RFB-2024-39
INTERIOR RENOVATIONS TO SCHENECTADY COUNTY DEPW
C2 DESIGN GROUP

ADDENDUM #3

Issued Date: 08/02/2024

Drawn By: C2 Architecture
Scale: As Noted
Date: 05/31/2024
Job No: 2407
Sheet Title:
**CONSTRUCTION PHASING
PLAN & NOTES**
Sheet Number:
G103

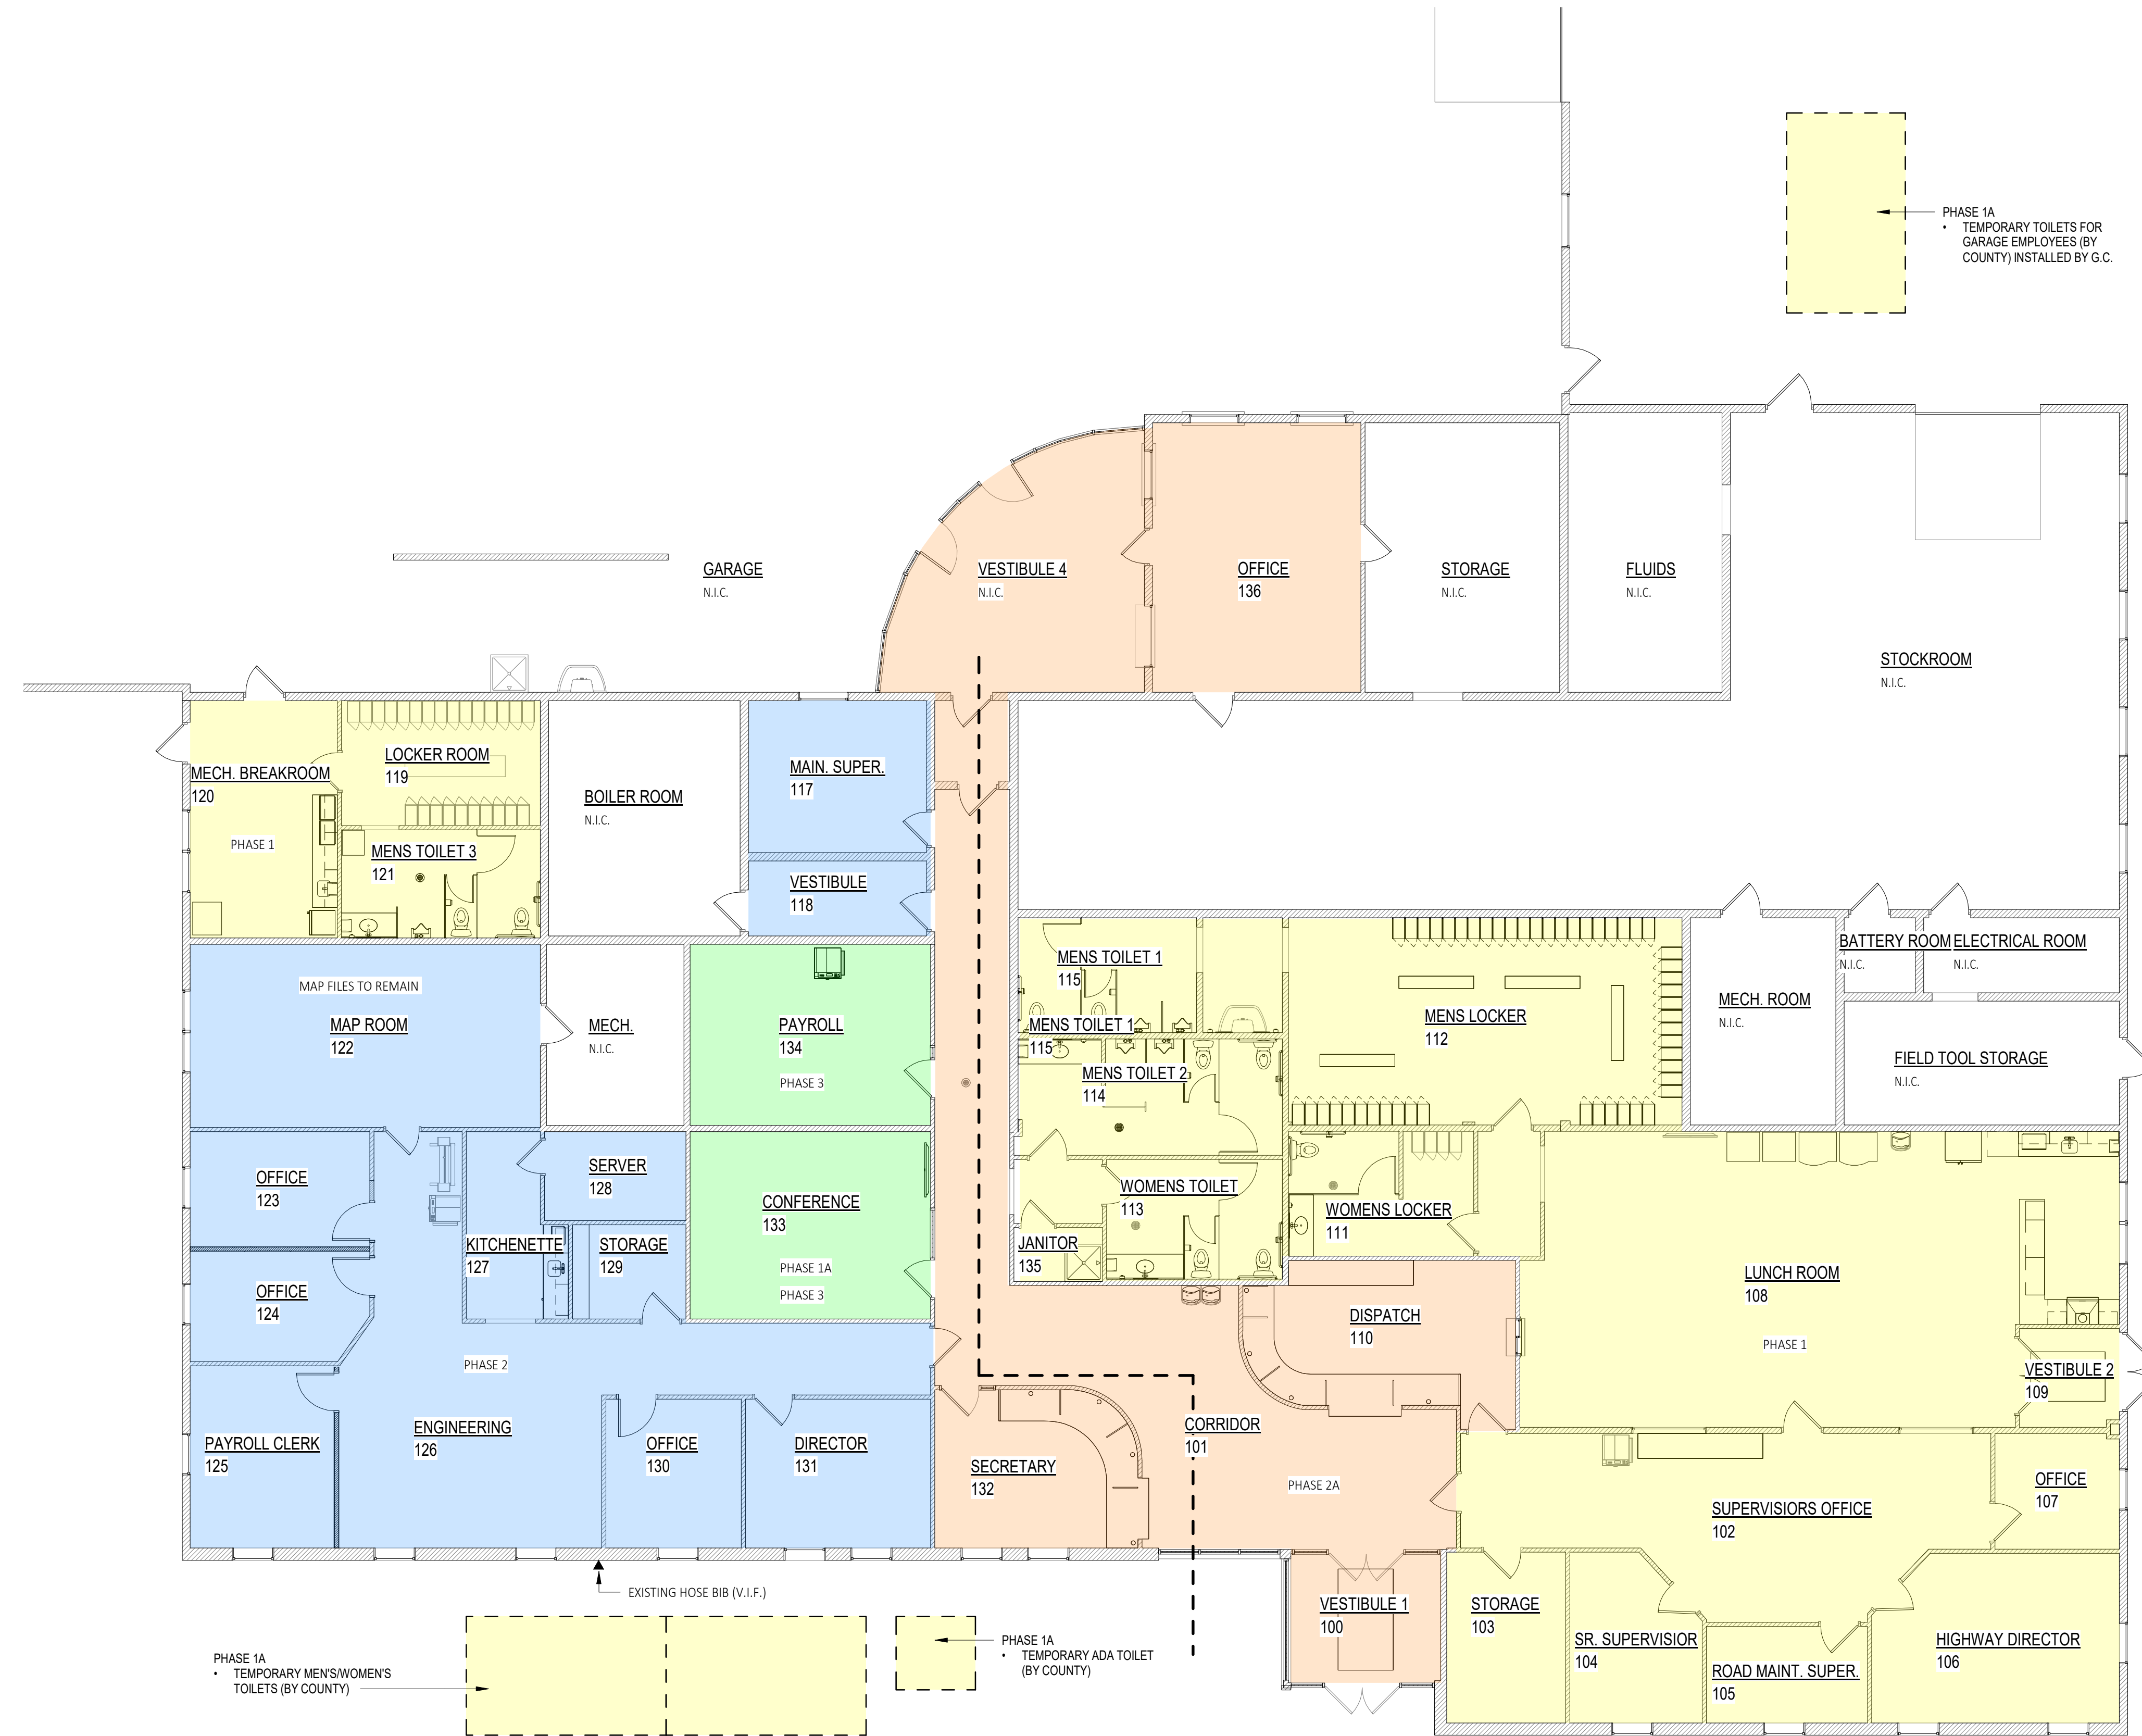
1. New Drawing G103 – Construction Phasing Plan & Notes
2. Drawing D101 – Enlarged Demolition plan – East
 - a. Key reference to replacement of lobby water cooler See plumbing drawings.
3. Drawing D102 – Enlarged Demolition Plan – West
 - a. Key reference for removal of cover at existing skylight
4. Drawing A102 – Enlarged Floor Plan – West
 - a. Reference for existing skylight
5. Drawing A800 – Reflected Ceiling plan
 - a. Key reference for finish of existing skylight

Sheet Number:
P101

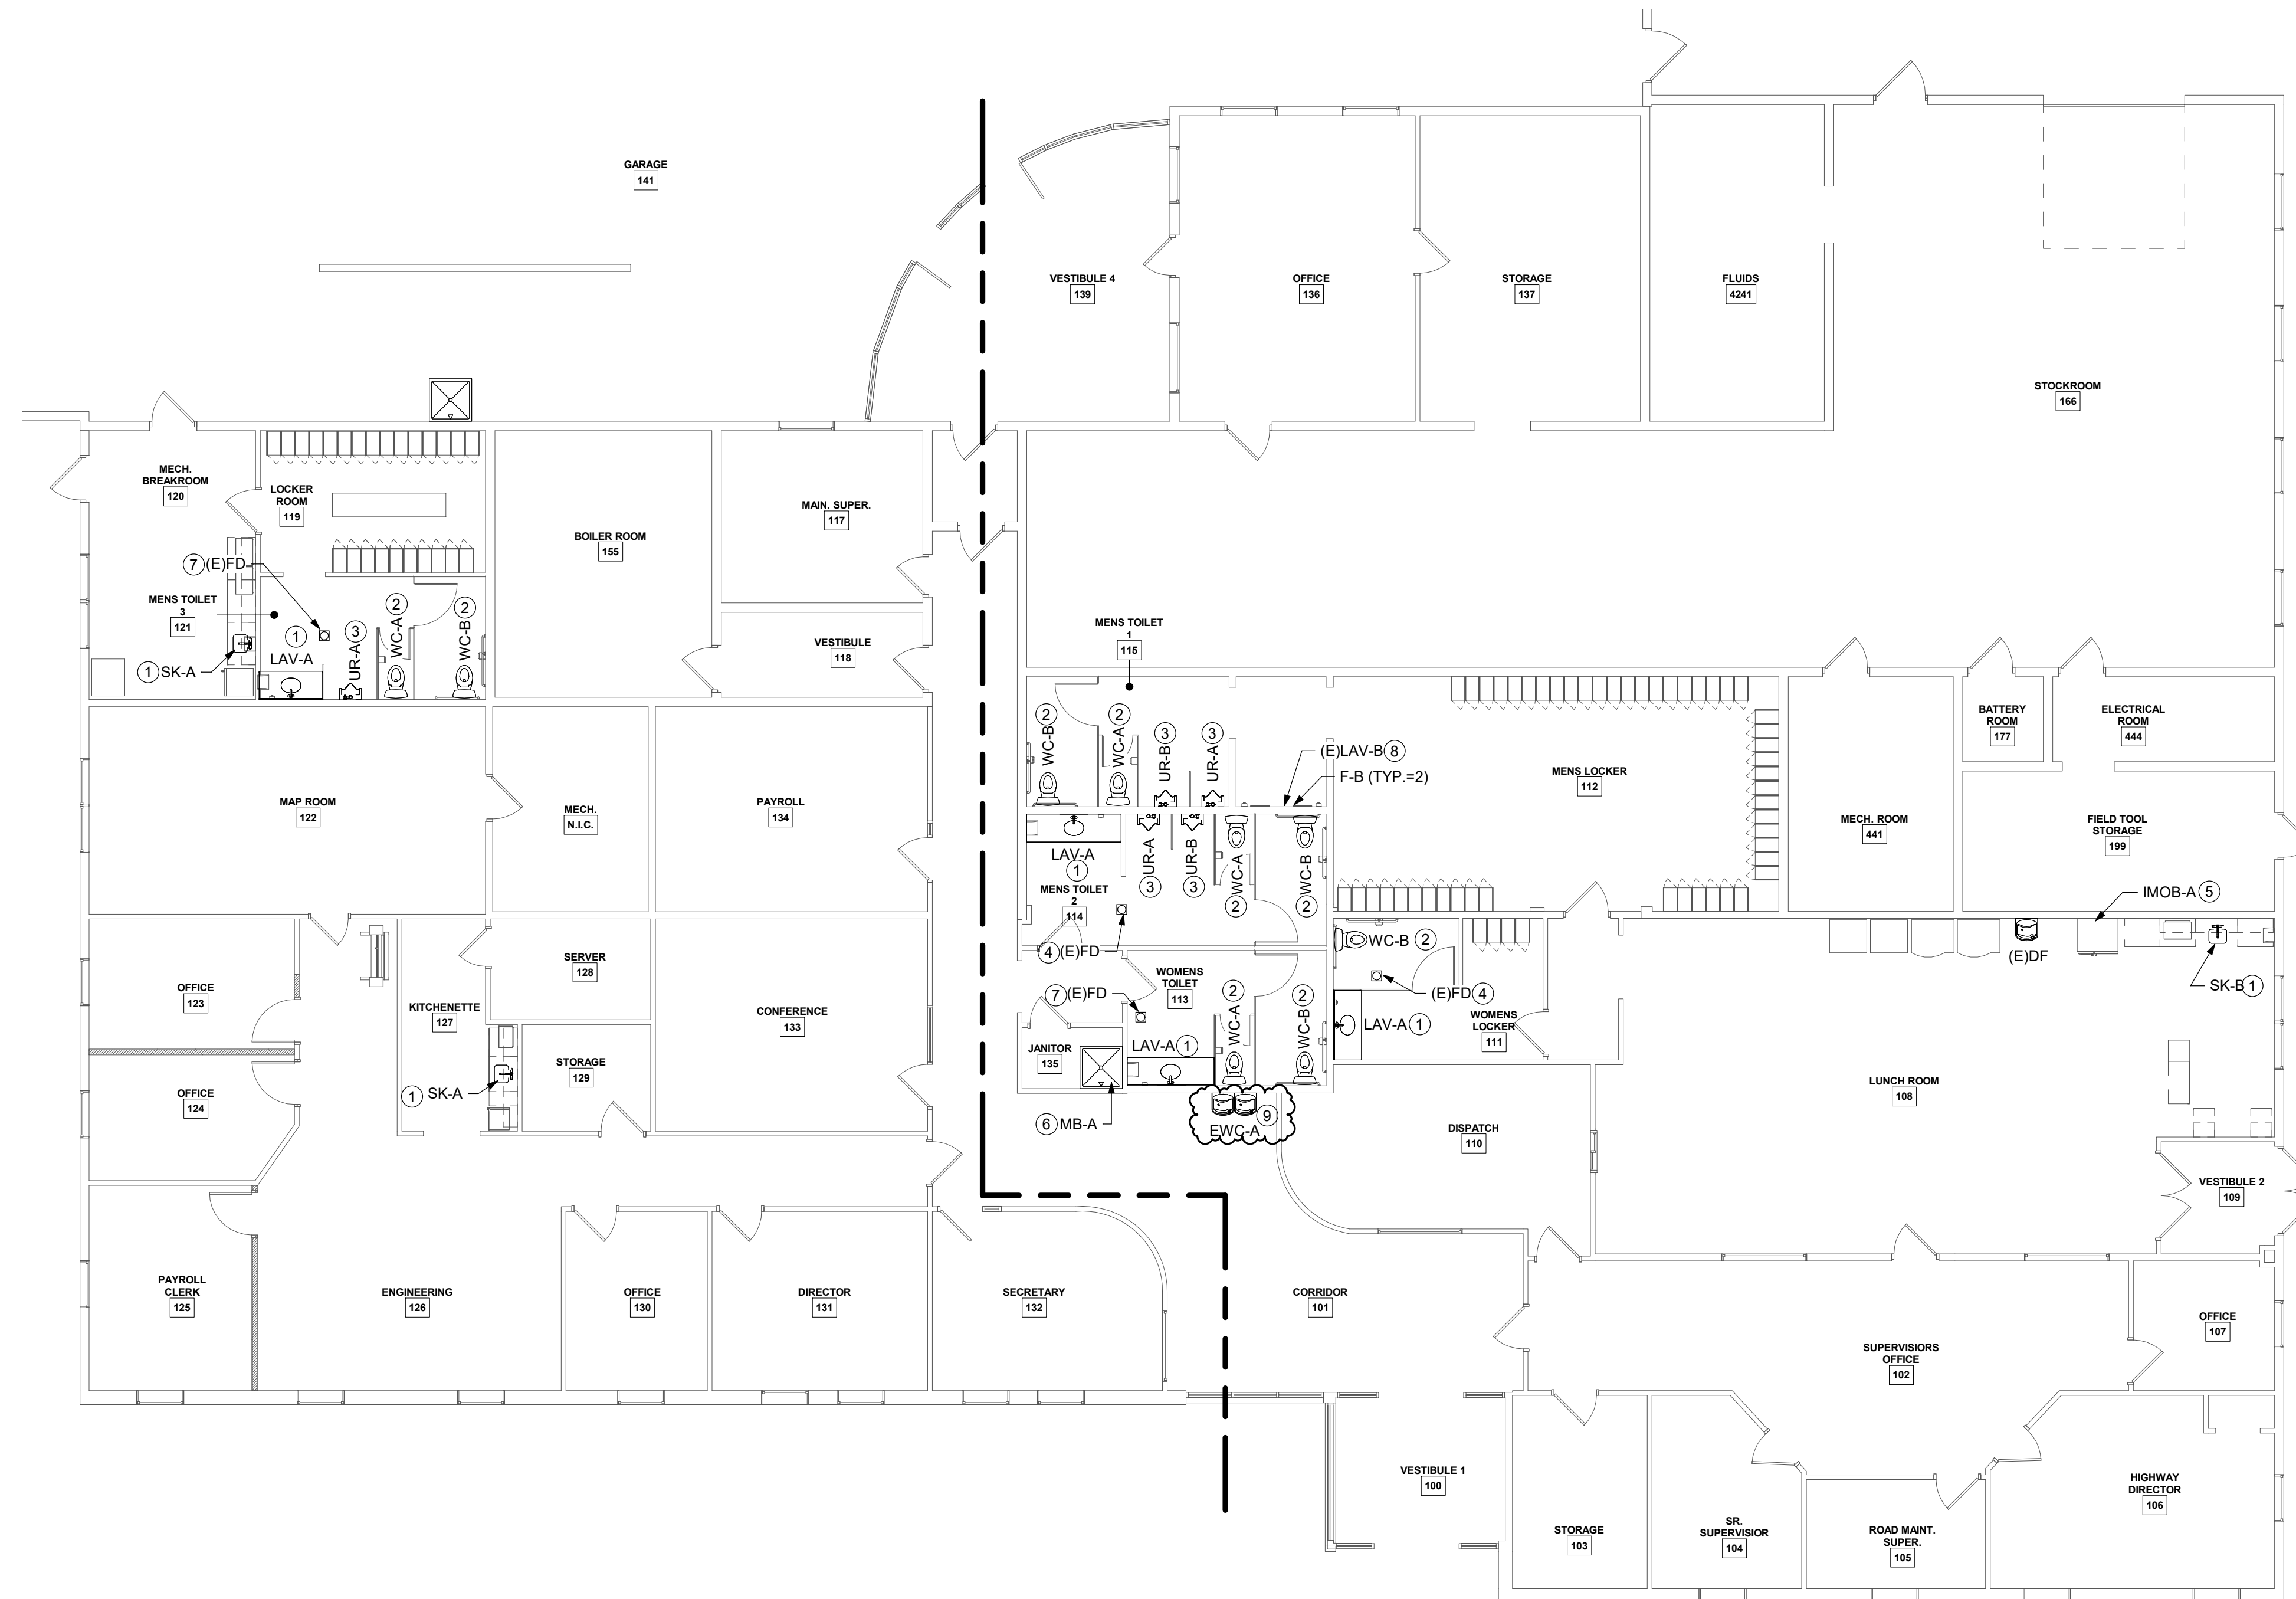
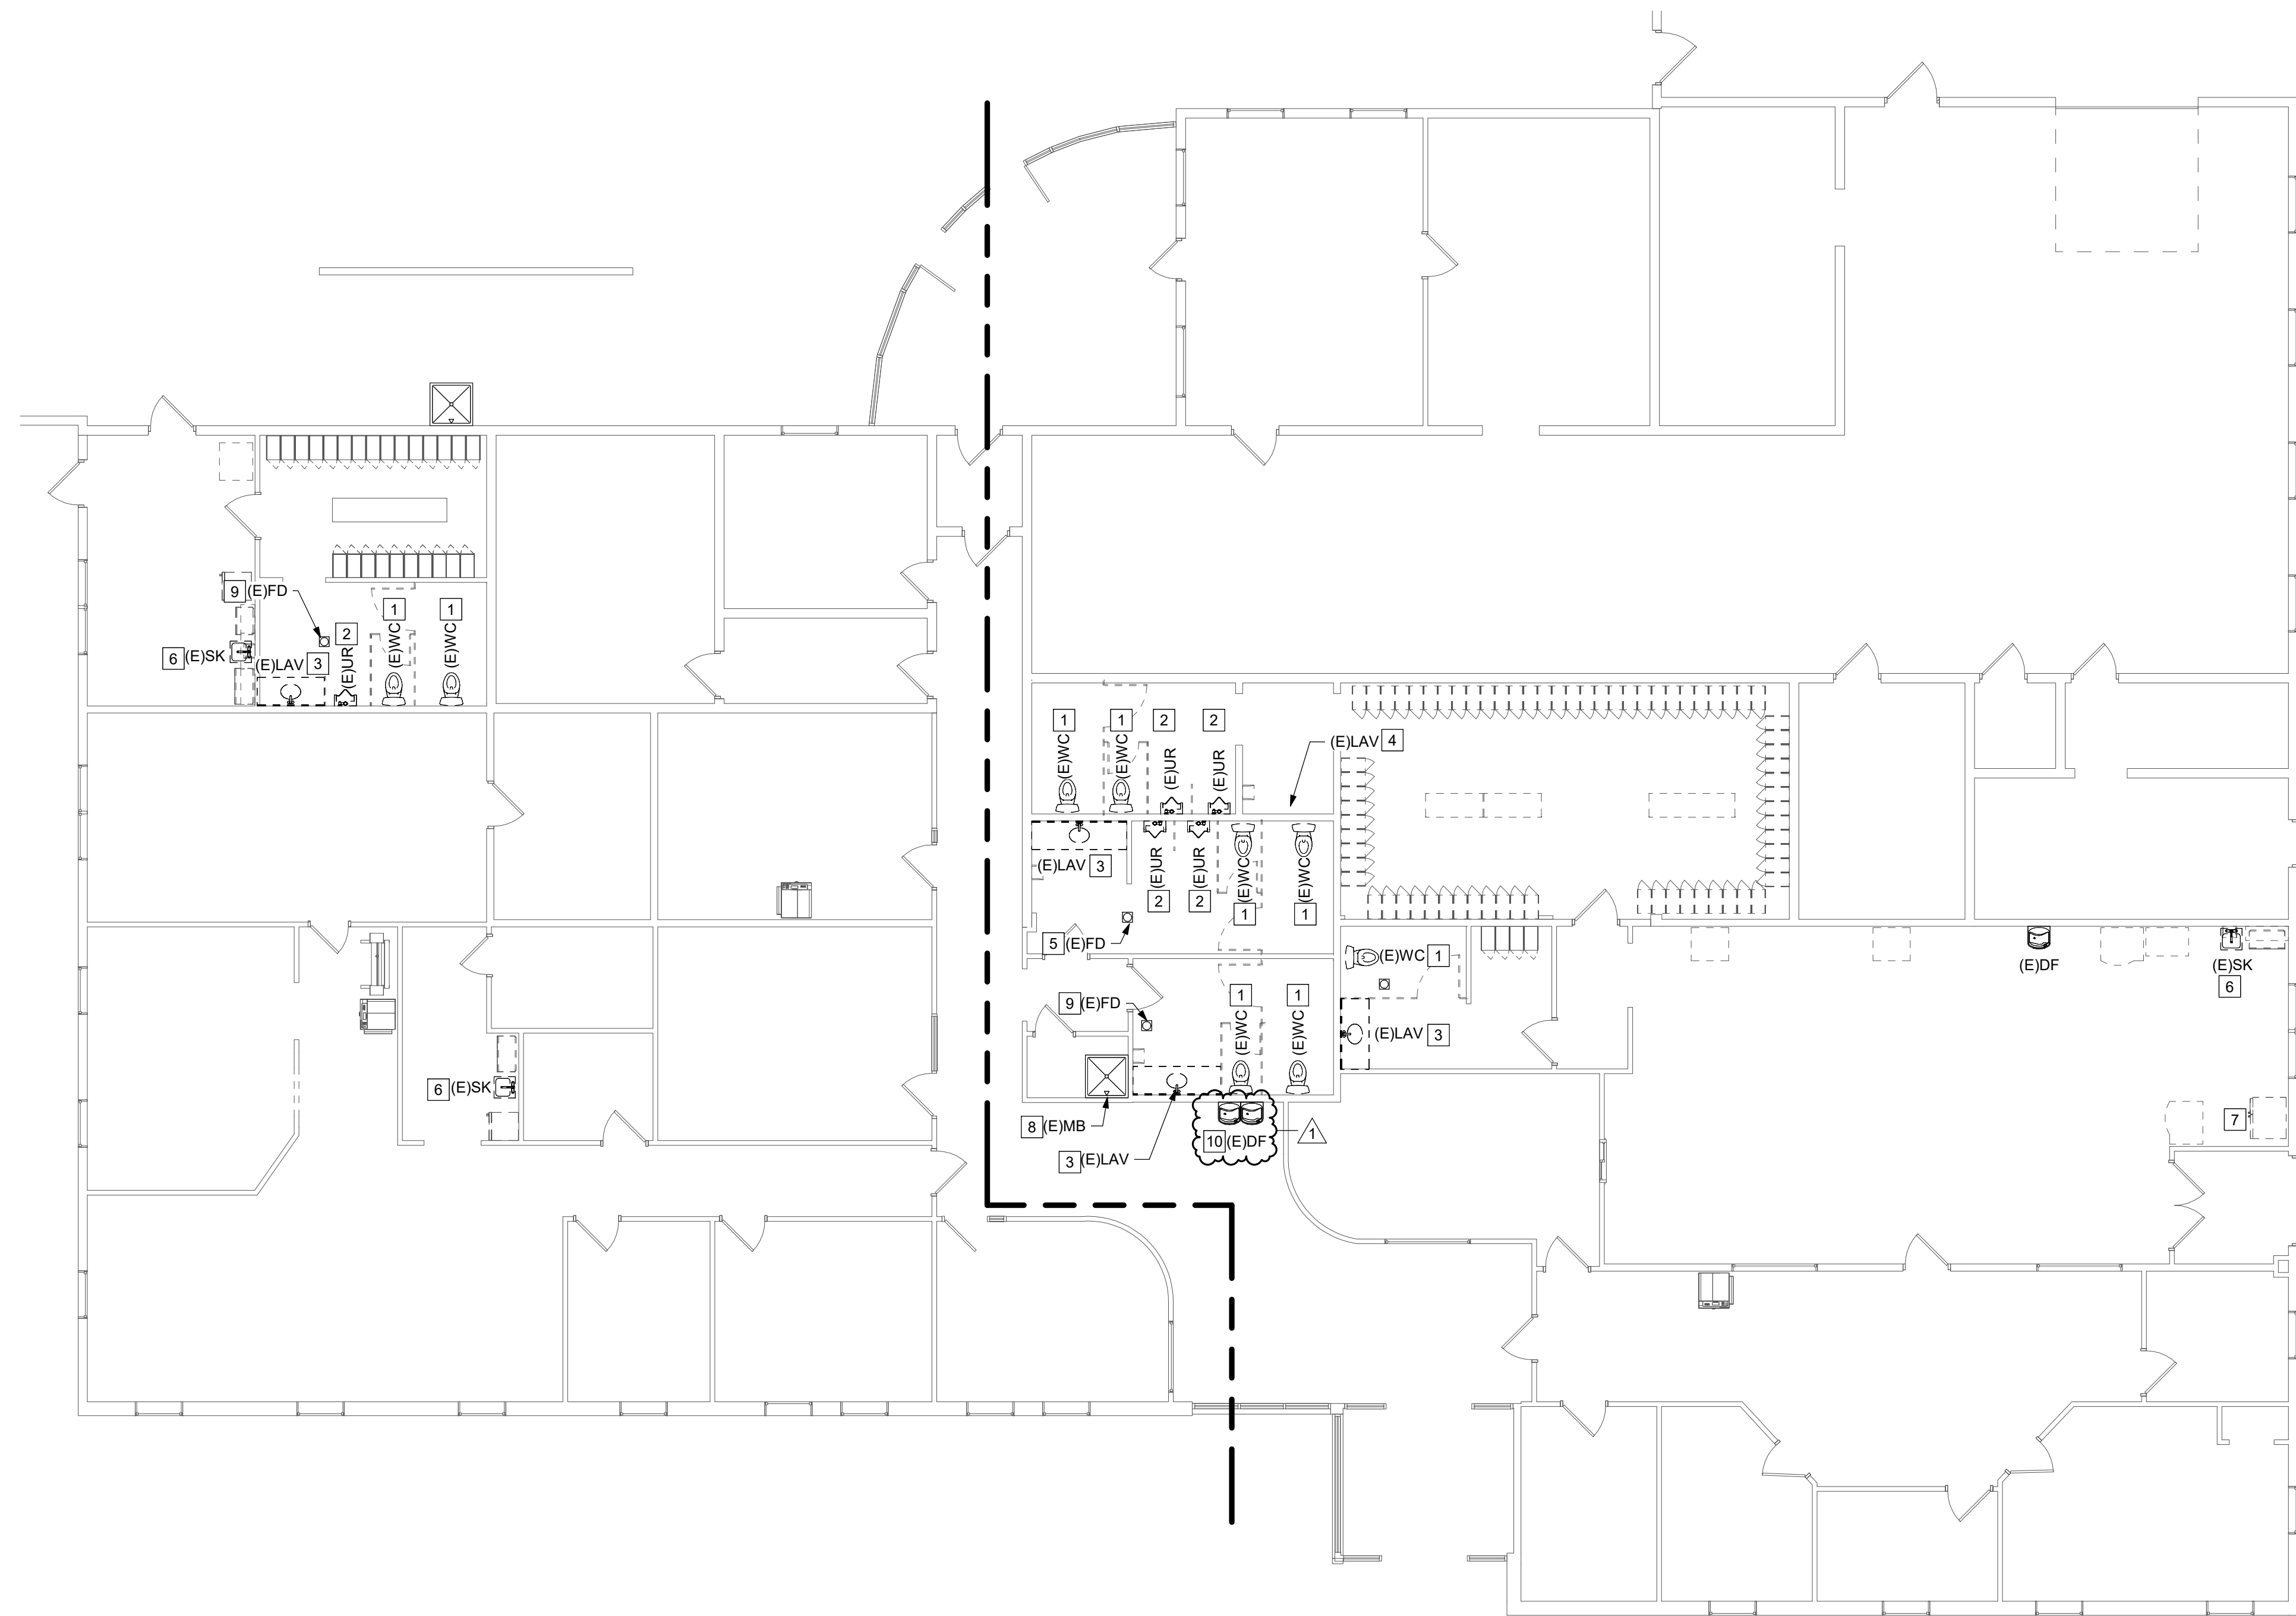
- a. Reference for EWC-A
8. Drawing PD101 – First Floor Demolition Plan - Plumbing
 - a. Reference demo. of existing water cooler
9. Drawing M101 – First Floor Plan (Overall) - HVAC

- 9 PROVIDE NEW CARRIER AND ELECTRIC WATER COOLER WITH BOTTLE FILLER AT THIS LOCATION. CONNECT TO EXISTING WASTE AND COLD WATER SUPPLY IN WALL.
